Table of Contents – Chapter II

This section of the Responses to Comments addresses comments related to the new NPDES permit’s regulation of Merrimack Station’s discharges of waste heat (also referred to as “thermal discharges”) to the Hooksett Pool section of the Merrimack River. In prior documents, Region 1 has discussed in detail the source and character of the Facility’s thermal discharges, as well as the legal requirements governing regulation of such discharges. *See, e.g.*, AR 608 (the Fact Sheet for Merrimack Station Draft Permit (“the 2011 Fact Sheet”) (Sept. 29, 2011), pp. 4-11; AR 618 (Attachment D to the 2011 Fact Sheet: Clean Water Act NPDES Permitting Determinations for the Thermal Discharge and Cooling Water Intake Structures at Merrimack Station in Bow, New Hampshire (“the 2011 Determinations Document”) (Sept. 29, 2011); AR 1533 (Joint Public Notice for the Reopening of the Public Comment Period for the Draft NPDES Permit for Merrimack Station ...) (“the 2017 Public Notice”) (August 2, 2017); AR 1534 (Statement of Substantial New Questions for Public Comment (Discussion of Substantial New Questions and Possible New Conditions for the Merrimack Station Draft NPDES Pe

Figure II.1. Mean daily (24-hour average) temperature (deg C) at Stations S0 (discharge), S4 (downstream), and N10 (ambient) from June 21 through September 30, 2004 compared to the yellow perch avoidance temperature (28.3°C). effort (CPUE) 22.00

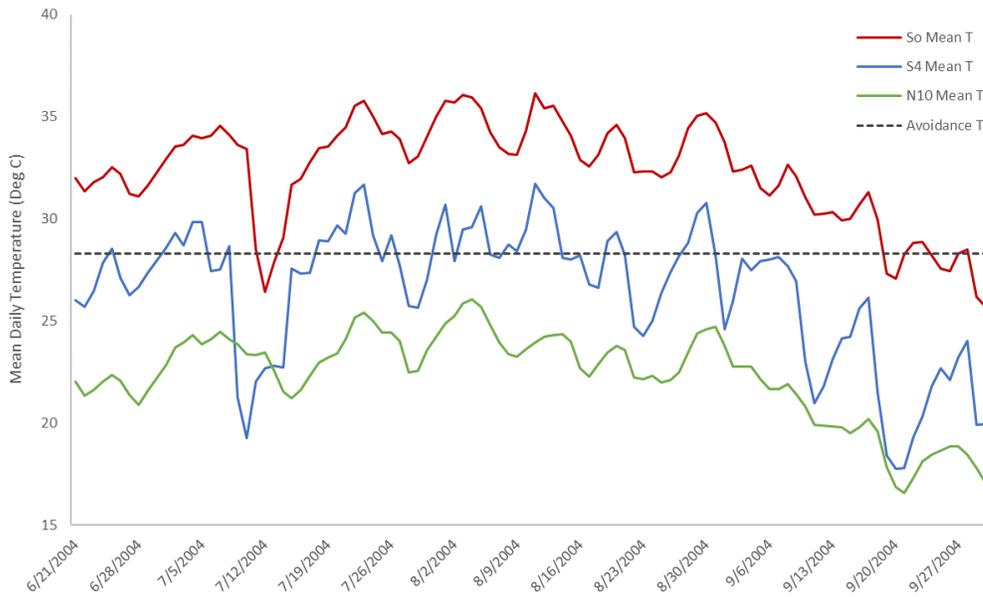
- Fact Sheet at 84-85: Comparing the 21-year Normandeau data set to Applied Science Associates, Inc.'s 2009 temperature study period and discrediting the 2009 data as not representative of typical river conditions by utilizing the misinterpreted Normandeau data;

- Fact Sheet at 89: Incorrectly asserting that the averaged maximum temperatures at Station S4 exceeded 84°F every day from June 25 to September 8;
- Fact Sheet at 93: Incorrectly asserting that that the average maximum temperature at Station S4 exceeded 85°F every day from June 25 to September 3;

- Fact Sheet at 93-94: Incorrectly asserting that the averaged maximum temperatures at Station S0 reached 92.9°F in mid-June;
- Fact Sheet at 104: Incorrectly asserting that the average daily maximum water temperatures at Station S0 ranged from a low of 79.2°F on May 3 to a high of 94.3°F on June 12;

PSNH comments that EPA’s misinterpretation of Normandeau’s 2007 Thermal Model Report is a cornerstone of the Agency’s entire § 316(a) analysis and, as a result, the assertions and/or conclusions of the analysis are called into question. PSNH also provides a “representative sample of instances” from the 2011 Draft Determinations Document where erroneous conclusions were based on this misinterpretation of data.

EPA acknowledges that the temperature data at issue was an integral part of its analysis of the Facility’s thermal impacts in the 2011 Determinations Document and, therefore, a key factor in its proposed decision to reject PSNH’s requested variance under CWA § 316(a). (As PSNH’s consultants have acknowledged, though it is not mentioned in the above comment, EPA’s misinterpretation of the data resulted from the misleading or unclear way in which it was presented by the Facility.) EPA’s misinterpretation of temperature data (due to a lack of clarity in presentation) does not, however, necessarily support either that PSNH’s proposed § 316(a) variance should be granted or that the BIP will be protected. Instead, it supports a re-examination of the in-stream temperature data and the potential of the Facility’s thermal discharge to impact

Figure II.2. Mean and maximum daily (24-hour average) temperature (deg C) at Stations S0 (discharge) and S4 (downstream) from August 10 through September 30, 2010 compared to the juvenile alewife avoidance temperature (28.9°C).

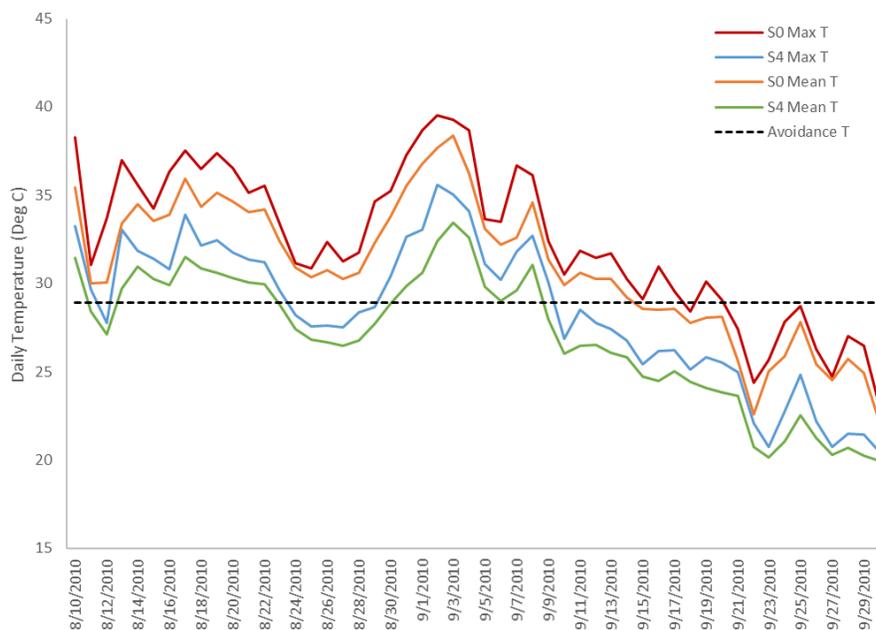
Based on the 2016 averaged data summary, LWB states that the average maximum temperature only exceeded 28.9°C on 14 days between July 16 and August 10, which is before juvenile alewife would be migrating. *See* AR-1300 p. 35, AR-1299. LWB and PSNH conclude that temperatures will be protective during the period in which alewives would be migrating past Merrimack Station. *See id.* EPA reviewed *daily* temperature data over the period from 2004 through 2018. The maximum daily temperature at Station S0 and S4 frequently exceeds 28.9°C after August 10 through early September, including as late as September 22 (at Station S4) and September 28 (at Station S0). Daily data from 2010 demonstrate that the mean daily temperature at S4 during that year was above 28.9°C from August 13 through August 22 and again from August 31 through September 9, and that the maximum daily temperature exceeded 28.9°C for nearly the entire period from August 10 through September 9 (Figure II.2, below). The daily data demonstrates that, in contrast to the LWB’s analysis and consistent with EPA’s conclusion in the 2011 Draft Determinations Document, temperatures in the river are above the protective temperature during the period when outmigrating juvenile alewife are present.

At the same time, EPA acknowledges that juvenile alewives could potentially avoid higher temperatures if the plume were sufficiently limited to allow areas of passage. The 2016 data demonstrate that the average daily temperature at Station S0 is less than the avoidance temperature of 28.9°C (84°F) on each day beginning on September 5, which indicates that river temperatures at S0 appear to be suitable for juvenile alewives by the end of the first week of September. When operating as a baseload plant, such as in 2010, the sustained, elevated temperatures could potentially exclude juvenile alewife from habitat downstream of the Merrimack Station for sustained periods, including when juveniles are outmigrating and must

travel through the lower Hooksett Pool. However, under current operations (like a peaking plant) Merrimack Station operates infrequently in August and September, and, as a result, the temperature at Station S4 is typically well below the avoidance temperature for juvenile perch. As an example, Figure II.3 presents the mean and maximum observed temperatures at Stations S0 and S4 in August and September 2016, when the capacity of the Station was, on average, 9%. Excursions of protective temperatures for juvenile alewives are limited in duration and extent. This data suggests that, under current operations, the thermal plume is unlikely to impact juvenile alewives because juveniles can avoid the plume and will not be excluded from potentially suitable habitat for extended periods of time.

Figure II.5. Mean and maximum daily (24-hour average) temperature (deg C) at Stations S0 (discharge) and S4 (downstream) from June 16 through September 10, 2007 compared to the juvenile and adult perch avoidance temperature (28.3°C).

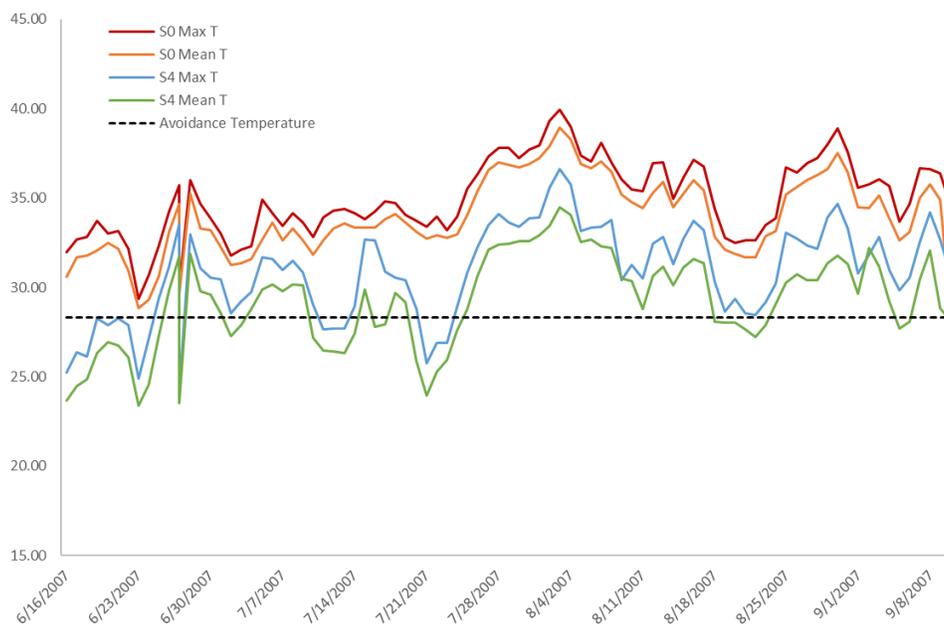
In the 2011 Draft Determinations Document, EPA concluded that temperatures at Station S4 reached or exceeded the avoidance temperature for yellow perch juvenile and adults (28.3°C) every day from June 15 to September 10. *See* AR-618 p. 106. Correctly interpreted, the maximum temperature from June 15 to September 10 was reached at Station S0 in at least one year out of this 21-year data set but not necessarily in the same or sequential years. LWB comments that, based on the average daily temperature data over the period from 2002 through 2015 (received in 2016), the 14-year average mean daily temperature at Station S4 did not exceed 28.3°C (83°F) on any calendar day during this period and the average daily maximum temperature reached or exceeded 28.3°C on 22 calendar days between July 16 and August 10. LWB also comments that juvenile and adult yellow perch would avoid the plume during the hottest part of the day when the S4 temperature exceeds the avoidance temperature. *See also* AR-872 p. 107-8. EPA notes that there are only 26 dates between July 16 and August 10, so the data shows the maximum average daily S4 temperature over the period 2002 through 2015 exceeded 28.3°C nearly all of the time between July 16 and August 10. EPA's review of daily temperature data from 2004 through 2011 indicates that the mean and maximum S0 and S4 temperatures steadily exceed 28.3°C between June 15 and September 10 in most years under baseload conditions, consistent with the analysis in the 2011 Draft Determinations Document. As an example, Figure II.5 illustrates persistent temperatures at the discharge and downstream that exceed the avoidance temperature for juvenile and adult yellow perch for the entire summer period. Even if adults and juveniles can avoid the plume by staying, as LWB suggests, in the cooler water upstream of the discharge, the thermal plume from Merrimack Station plainly caused a portion of Hooksett Pool to be unsuitable for yellow perch for the entire summer in multiple years.

However, the potential impacts of the thermal plume on juvenile and adult yellow perch have changed substantially since 2012 when Merrimack Station transitioned to a peaking plant. Figure II.6 illustrates that, under current operating conditions (in 2016, which is representative of above average operating capacity compared to recent summers), the mean and maximum daily temperature at Station S0 only occasionally reached or exceeded avoidance temperatures for yellow perch and exceedances that did occur were limited to a few days. The mean daily temperature at Station S4 did not exceed avoidance temperatures for yellow perch and the maximum temperature rarely exceeded the avoidance temperature. The data suggests that, under current operations, juvenile and adult yellow perch are likely to avoid the plume and will not be excluded from potentially suitable habitat for extended periods of time. EPA has also determined, in response to this and other comments received, that acute mortality is not likely to occur as a result of exposure to the thermal plume first because under current operations it is uncommon for river temperatures to exceed the acutely lethal temperature between Stations S0 and S4 and second, because yellow perch juveniles are mobile and can avoid the relatively rare extreme temperature events that may occur for limited periods of time in the segment of the river between Stations S0 and S4. *See* Response to Comment II.3.4.7. Finally, PSNH and LWB comment that protective temperatures for yellow perch maturation during the winter is “highly speculative.” EPA addresses comments on protective temperatures during the yellow perch maturation period in detail in Response to Comment II.3.4.7.

Figure II.7. Mean and maximum daily (24-hour average) temperature (deg C) at Stations S0 (discharge) and S4 (downstream) from June 4 through July 2, 2007 compared to the larval white sucker lethal temperature (31.7°C).

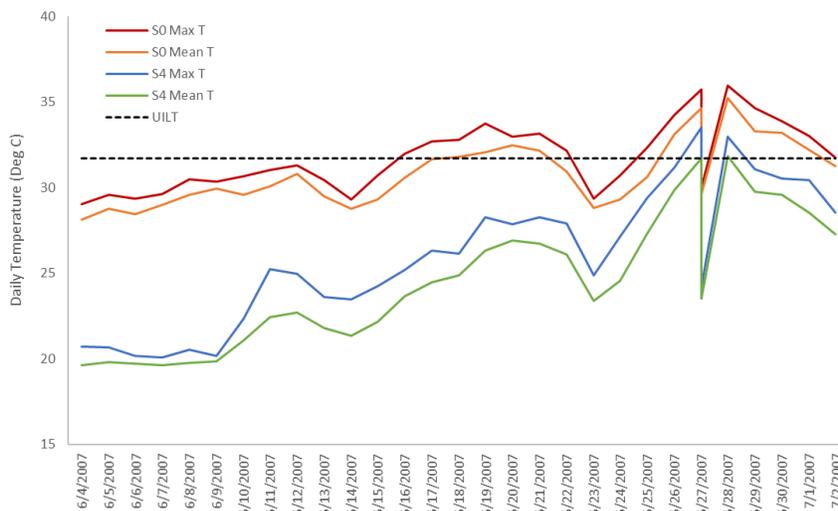
In the 2011 Draft Determinations Document, EPA concluded that maximum daily temperatures at Station S0 and S4 exceeded lethal temperatures for white sucker larvae (30°C - 31.7°C) when larvae are present in the Merrimack River. *See* AR-618 p. 112. Correctly understood, however, the 2007 Normandeau report data only showed that the maximum temperature from June 4 to July 2 reached potentially lethal temperatures on each day in at least one year out of the 21-year data set and did not necessarily reach that level on multiple days in the same year or in sequential years. According to LWB, the 2016 temperature data show that the average daily maximum temperature during all dates between June 4 and July 2 never exceeded the white sucker upper incipient lethal temperature at either station. *See* AR-1300 p. 36-7. Reviewing the daily temperature data for June 4 to July 2 for the years 2004 through 2018, however, demonstrates that the daily maximum and mean temperature at S0 frequently exceeded 31.7°C in every year from 2004 to 2011 on multiple, consecutive days (except in 2006, when there was only one exceedance of 30°C). The mean daily temperature at Station S4 exceeded 31.7°C on only two dates (at the end of July in 2007) over the entire period, while the maximum daily S4 temperature exceeded 31.7°C in three of the years (on 2 consecutive days in 2004, 6 days in 2007, and 7 days in 2010). As an example, Figure II.7 presents the mean and maximum daily temperatures at S0 and S4 for this time period in the year 2007. Re-examining the observed daily temperature data supports the 2011 Draft Determinations Document's conclusion that white sucker larvae could be exposed to potentially lethal temperatures in the thermal plume during the period when they are likely to be present, including, in some years, in early to mid-June when surface-feeding yolk-sac larvae are expected to be present. *See* AR-618 p. 113-14. At the same time, temperatures fell, on average, 4°C to 10°C between Stations S0 and S4, and temperatures were typically below the UILT by Station S4, suggesting that the duration of exposure to

potentially lethal temperatures would be limited in most cases. In addition, temperatures have not exceeded the UILT at Station S4 since 2012, when operations transitioned to a peaking-like plant, with a single exception (maximum daily temperature on 7/2/2018). As a result, EPA concludes that the Final Permit's limits, which include an acute mortality limit at Station S4, will ensure that conditions in the river are protective of white sucker larvae and will not result in acute mortality. *See* Response to Comment II.3.4.7.

Figure II.8. Mean and maximum daily (24-hour average) temperature (deg C) at Stations S0 (discharge) and S4 (downstream) from June 25 through September 1, 2007 compared to the avoidance temperature for juvenile and adult white sucker (29.9°C).

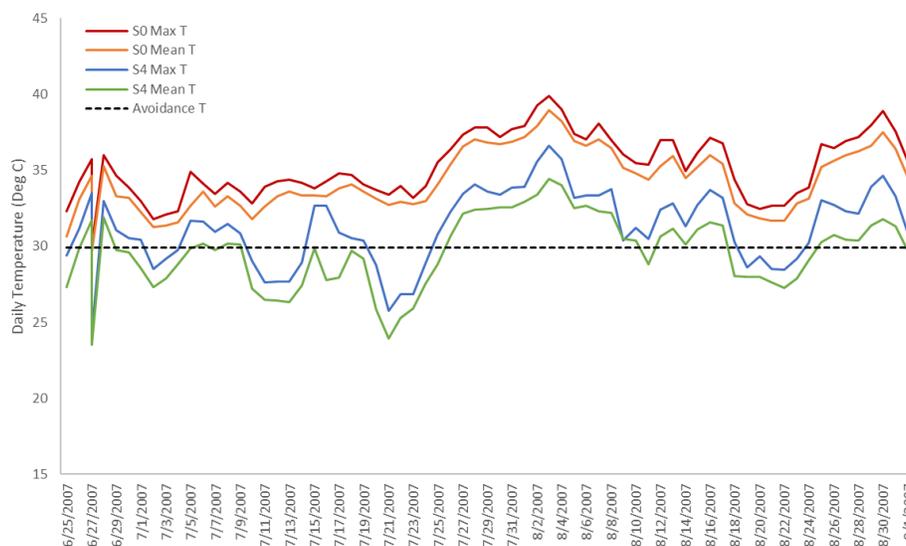
In the 2011 Draft Determinations Document, EPA concluded that maximum daily temperatures at Station S4 routinely exceeded avoidance temperatures for white sucker juveniles and adults (29.9°C) every day from June 25 to September 1, while average maximum temperatures at Station N10 remained below 29.9°C. *See* AR-618 p. 112. Correctly understood, the 2007 Normandeau report data only showed that the maximum temperature from June 25 to September 1 exceeded avoidance temperatures on each of those days in at least one year out of the 21-year data set, but did not necessarily do so on multiple days in the same year or in sequential years. According to LWB, the 2016 report presenting the average of the multi-year temperature data shows that the average daily maximum temperature at Station S4 reached 29.4°C (85°F) on only 3 dates during July, and never exceeded the avoidance temperature (29.9°C). *See* AR-1300 p. 37. *See also* AR-872 p. 112. Yet, reviewing the actual, observed daily temperatures demonstrates that the daily maximum and mean temperature at S4 routinely exceeded 29.9°C between June 25 to September 1 in 2004, 2005, 2007, 2010, and 2011, albeit not every day. Figure II.8, from 2007, supports the 2011 Draft Determinations Document's conclusion that daily maximum and, in some cases, mean S4 temperatures reach avoidance temperatures for juvenile and adult white sucker for large portions of the summer.

LWB points out that white sucker adults and juveniles can avoid the thermal plume, for instance, by staying upstream of the discharge where ambient temperatures are in the preferred range. According to LWB, “these fish may prefer cooler water upstream from the discharge than warmer water below the discharge, although other habitat characteristics besides temperature could explain this distribution.” AR-1300 p. 14. Electrofish sampling in 2010 and 2011 (when the Facility was operating at a relatively high capacity) supports this assertion as catch-per-unit-effort (CPUE) for white sucker north of the discharge was more than four times higher than the CPUE at stations south of the discharge. *See* AR-871, p. 42 (where Group IIB2 is represented mainly by stations in northern Hooksett Pool and IIB1 is represented mainly by stations in southern Hooksett Pool). White sucker adults and juveniles can avoid the plume, but persistent, elevated temperatures downstream of the discharge could exclude these fish from this habitat for nearly the entire summer. Under current operating conditions (*i.e.*, operating like a peaking plant from 2012 through 2018), however, the maximum daily river temperature at Station S4 reached 29.9°C on several occasions but, with the exception of July and August 2012, the duration of the event was limited (5 days or less) and the mean daily S4 temperature did not exceed 29.9°C. The change in operations of the Station since 2012 has decreased the number and duration of events when the temperature at Station S4 reaches or exceeds the white sucker avoidance temperature, which suggests that the habitat downstream the discharge would typically be available to, and protective of, white sucker juveniles and adults. There was no difference in the CPUE for white sucker in the northern and southern sections of Hooksett Pool during electrofish sampling in 2012 and 2013, when the Facility ran 5-15 days in August and September. *See* AR-1551, p. 19.

Figure 1: Merrimack Quarterly Heat Input, 1995-Present²¹

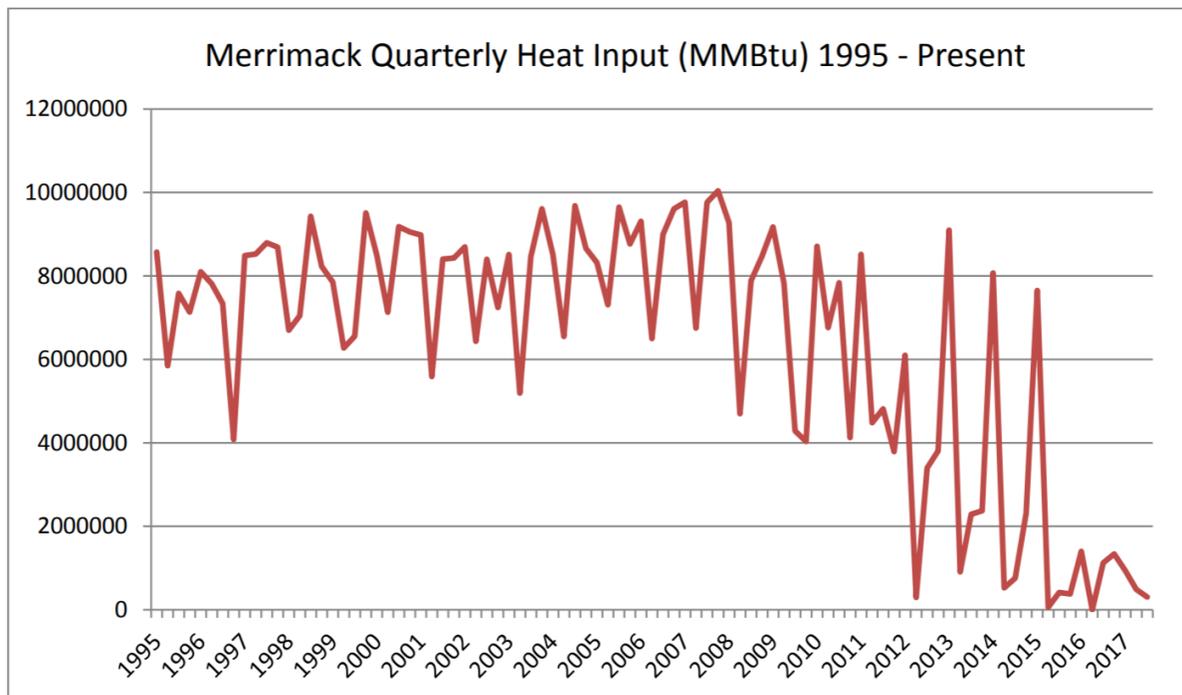
Second, as EPA implicitly recognizes, while Merrimack’s annual capacity factor may be lower in recent years than in years further back, it still operates quite heavily for short periods of time in the winter and in the summer. Setting limits based on annual output would improperly ignore Merrimack’s high level of operations, and concomitant environmental impacts, during those periods of time. This would be particularly troublesome given the seasonality of the thermal impacts described above, where it is precisely the thermal pollution Merrimack causes during the winter that provides a toehold for invasive species and threatens the balanced indigenous population of aquatic species in the Merrimack river.

Third, the unfortunate fact is that EPA is extremely slow in issuing NPDES permits for large facilities in New Hampshire, and for Merrimack in particular. These comments are submitted as part of the third round of comments solicited by EPA on this one permit, in a process that started over five years ago. Indeed, Merrimack has been operating under a permit that expired two decades ago, and was issued a quarter-century ago. Although Commenters certainly hope that EPA will finalize this permit soon, and will thereafter hew to the five-year permit review cycle mandated by Congress, the history of this permit and this plant raises the possibility that whatever permit EPA does finalize for Merrimack may govern the plant’s operation for many years to come. Just as Merrimack’s operation has changed considerably in the past, it is possible that it will vary considerably in the future.

As such, it would be both irresponsible and contrary to law for EPA to set NPDES permit limits for Merrimack based on an assumption that, because the facility currently operates at a relatively low capacity utilization, certain wastestreams and pollution levels are unlikely to be relatively high in the future and therefore need not be limited.

Figure II.9. Mean and maximum daily (24-hour average) temperature (deg C) at Stations S0 (discharge) and S4 (downstream) from October 1 through October 31, 2015 compared to the adult yellow perch avoidance temperature (28.9°C).

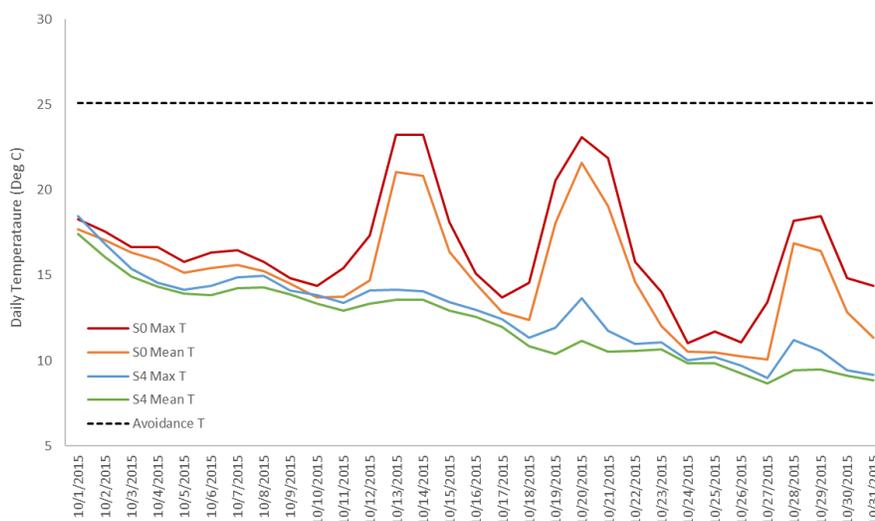
Yellow perch juveniles are the most thermally tolerant phase of the life cycle of yellow perch. McCormick (1976) found maximum growth rates at 28°C. Hokanson (1977) identifies 24.7°C as the physiological optimum for yellow perch based on studies using juveniles. EPA calculated an upper limiting temperature (28.4°C) using the method identified in the Gold Book. This upper limiting temperature is above the physiological optimum calculated in the 2011 Draft Determinations Document (26.4°C). EPA maintains that a weekly average limit of 28.4°C at Station S4 in October will be protective of yellow perch juveniles. Temperatures in the thermal plume are highest where the discharge canal meets the Merrimack River (Station S0) and decrease as the plume travels downstream. Under baseload operation during the month of October, the temperature decreased 3° to 10°C as the plume traveled from Station S0 to S4, which indicates that generally the plume will be quickly mixed when it joins the Merrimack River during October. River temperatures will continue to decrease downstream of Station S4 as the plume becomes fully mixed. Therefore, compliance with a weekly average temperature of 28.4°C at Station S4 ensures that the plume is at or better than the optimal range for yellow perch juveniles downstream of Station S4. Competitive interactions of yellow perch juveniles could be affected if the entire Hooksett Pool were at a temperature of 28.4°C because that is, as the comment points out, at the upper range for this species and might favor more thermally tolerant species. However, the thermal limits proposed in the 2011 Draft Determinations Document would ensure that, at most, only a small area of the river would be impacted by the plume and most of the Pool would be unaffected or at temperatures that are within the optimal range. Even water quality standards allow a limited area and volume of the river to be designated as a mixing zone within which water quality standards may be exceeded, but New Hampshire's water quality standards do not set specific instream temperature limits for the river.

Moreover, while EPA maintains that the proposed temperature would be protective of juvenile yellow perch, the effective temperature limit would be the most stringent water quality-based temperature limit proposed for the time period from October 1 through November 1, which would actually be 25.1°C (for adult yellow perch) and would also be sufficiently protective of juvenile perch. Finally, in recent years Merrimack Station has rarely operated in October (the highest average monthly capacity since 2012 was about 4% in 2015). Figure II.9 demonstrates the actual daily temperatures at Stations S0 and S4 in October 2015 which was the highest capacity year for the month of October since the Facility transitioned to operating like a peaking plant. Since 2012, the average rise in temperature at Station S4 as compared to Station N10 (ambient) was less than 0.5°C. Therefore, no problems are anticipated for yellow perch, or other species, during that time frame and EPA's limits for the Final Permit are sufficiently protective.

Figure 3-1. Trends in electrical generation by season at the Merrimack Station, 2007 - 2016.

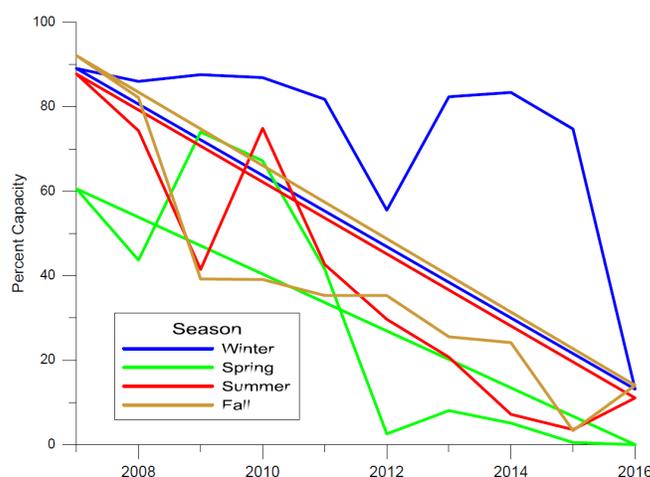
First, the potential thermal exposures should reflect likely operation of the Merrimack Station over the upcoming NPDES permit period (typically five years). As clearly demonstrated in ISO New England (2017), the Station no longer operates as a base-loaded facility as it had prior to

2010. Hence, temperature monitoring data collected prior to the draft NPDES permit (2011) does not reflect current conditions. The Merrimack Station operates principally as a peaking facility operating only when economic dispatch requires. A re-graphing of the generation data provided in ISO New England (2017) reveals a distinct seasonal pattern in operation (Figure 1). This graph clearly illustrates a substantial decline in the electrical generation at Merrimack since 2007 throughout the year except during winter. Hence, the magnitude and extent of thermal exposures to the aquatic community during most of the year are likely to be much lower than when Merrimack was operating as a baseload facility. During spring and summer, when biological productivity and potential for thermal stress is highest, Merrimack is typically operating at a capacity factor of less than 20 percent. That is only a small fraction of generating capacity of this facility prior to the 2011 draft NPDES permit. Only during winter, when natural gas availability constraints limit operation at other generating facilities is Merrimack called to run often. However, biological stresses from elevated temperatures at this time of the year should be minimal owing to low river water temperatures.
